SNUPPS

September 5, 1981
SLNRC 81-090 File:0541
SUBJ: MEB Review

Reference: NRC Summary of June 9-10, 1981 Meeting to Review
Mechanical Engineering, dated July 6, 1981

ENCLOSURE TO SLNRC 81-90
FSAR CHANGES

Figure 181 ^{3A-2}

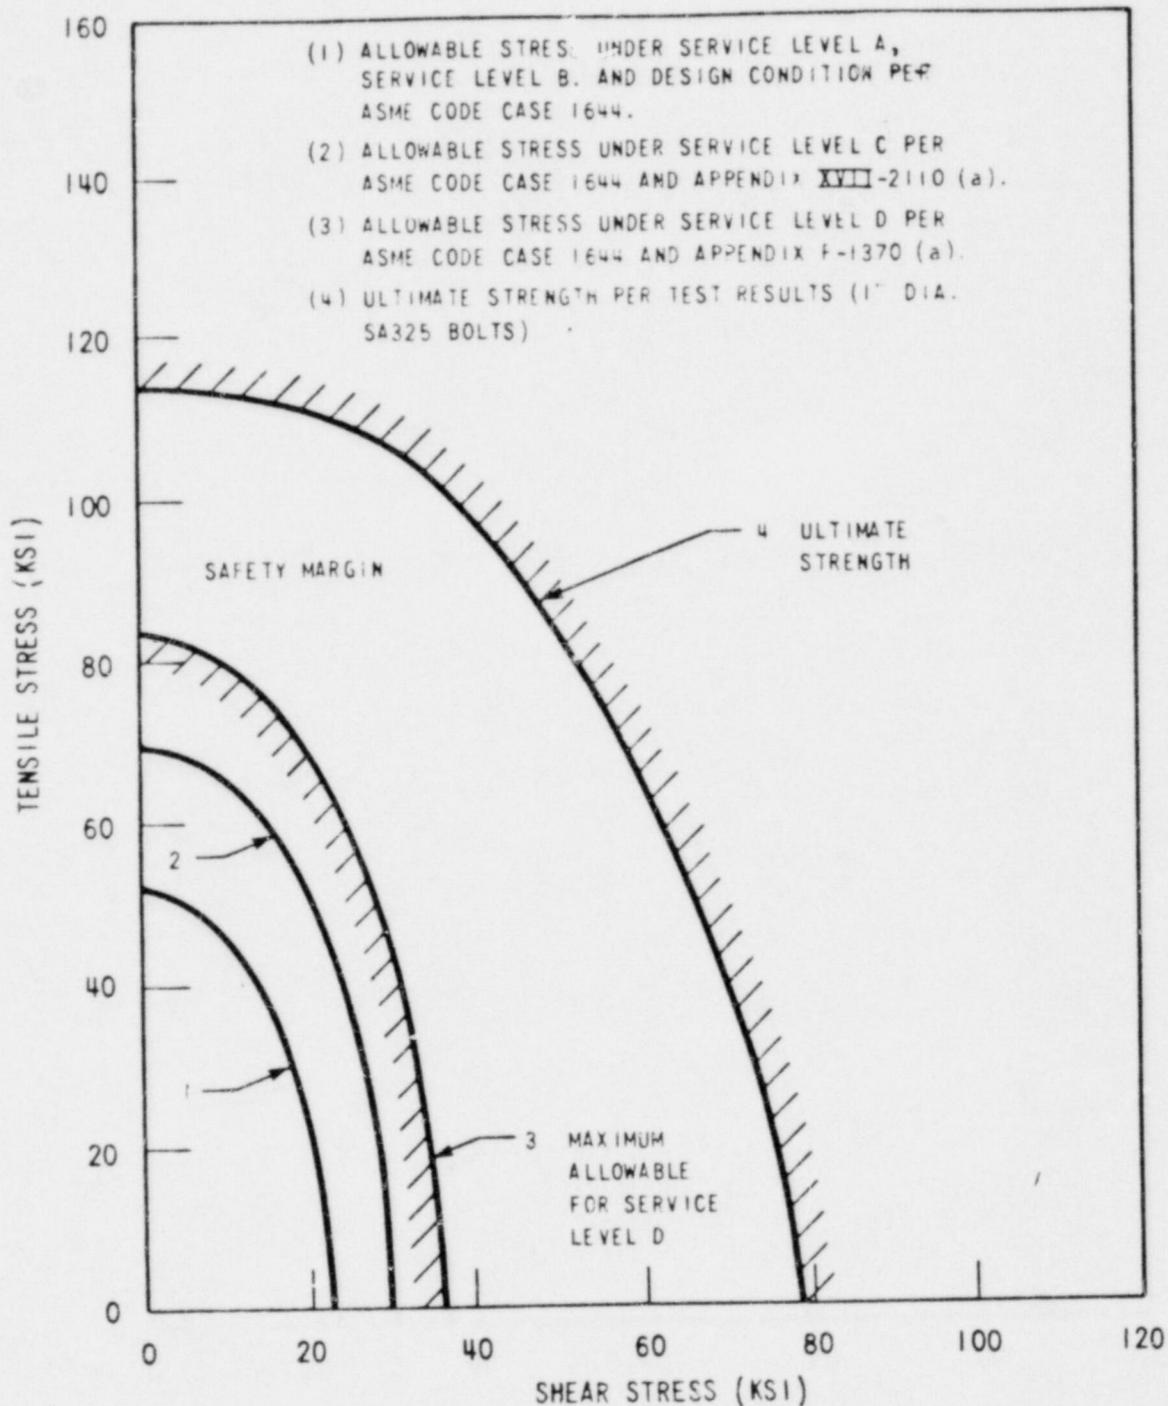
Figure 3A-2 shows the interaction curves for T-S loads on SA-325 bolts. Curve (1) represents the interaction relation (ellipse) permitted by Code Case 1644 (ASME III, Appendix XVII Winter 77 Addenda) for service levels A, B, and design condition. Curve (2) represents the interaction curve which considers the Code Case 1644 allowables and the increase permitted by XVII-2110(a) for service level C. Curve (3) represents the interaction curve which considers the Code Case 1644 allowables and the increase permitted by F-1370(a) for service level D. Curve (3) is the upper limit of the allowable stresses.

The design stress limits represented by Curves 1, 2, and 3 for A 325 bolts are then compared against the ultimate strength of the bolts represented by Curve 4, which is based on Chesson's test results. The area between Curve 3 and Curve 4 is the safety margin between the maximum bolt stress under service level D and minimum ultimate strength of the bolt.

Figure ~~182~~ ³⁰³
Factor of Safety Against Failure Under Service Level D as a Function of T-S Ratio

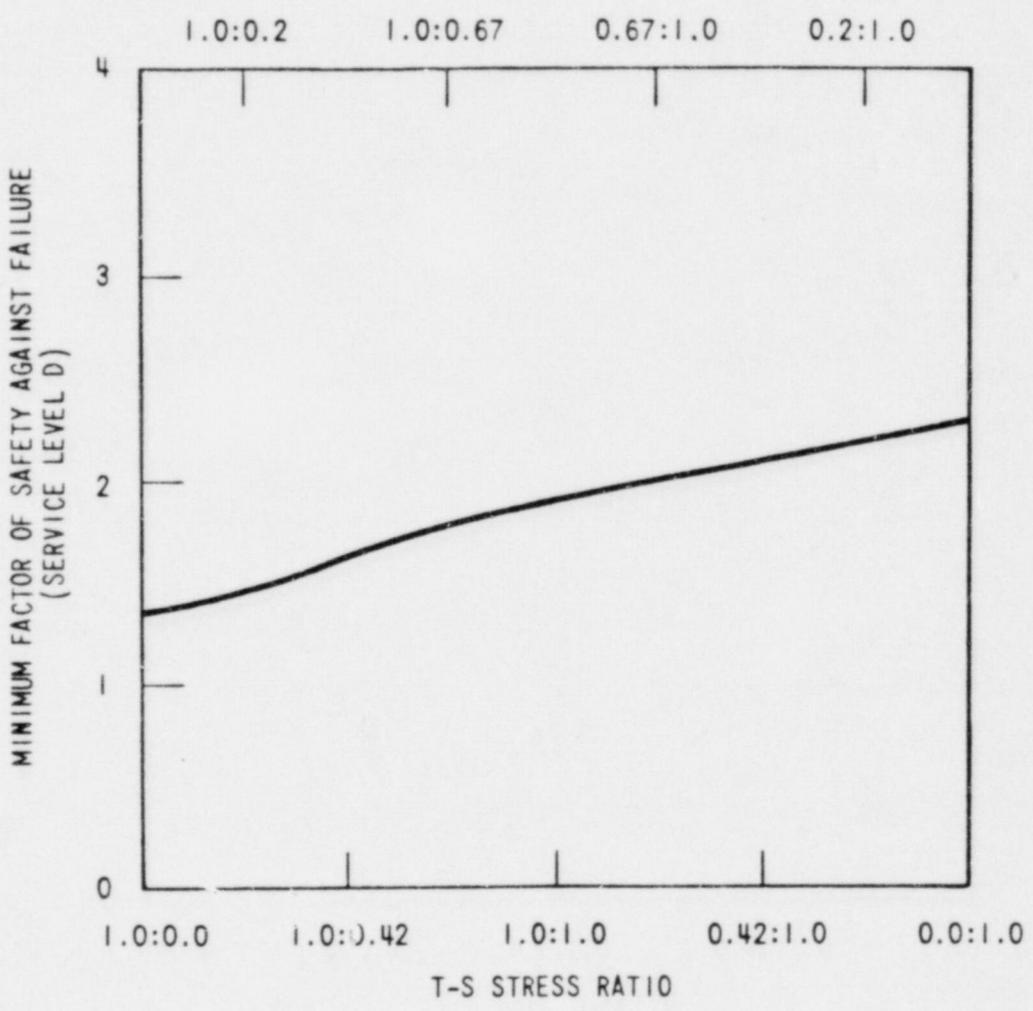
Factor of safety against failure for A 325 bolts for various T-S ratios is shown in Figure 3A-3. The safety factor varies between a minimum of 1.36 and a maximum of 2.29, depending upon the value of T-S ratio. This is based upon the ultimate strength of the bolts from Chesson's test and the allowables obtained from Code Case 1644 and the increase permitted by F-1370(a) for service level D. Figure 3A-3 demonstrates that there exists an adequate factor of safety for the complete range of T-S loadings.

- (1) For the emergency condition, the safety factor (ratio of ultimate strength to allowable stress) varies between a minimum of 1.63 and a maximum of 2.73, depending upon the actual tensile stress/shear stress (T/S) ratio on the bolt.
- (2) For the faulted condition, the safety factor varies between a minimum of 1.36 to a maximum of 2.29, again depending upon actual T/S ratio on the bolt.
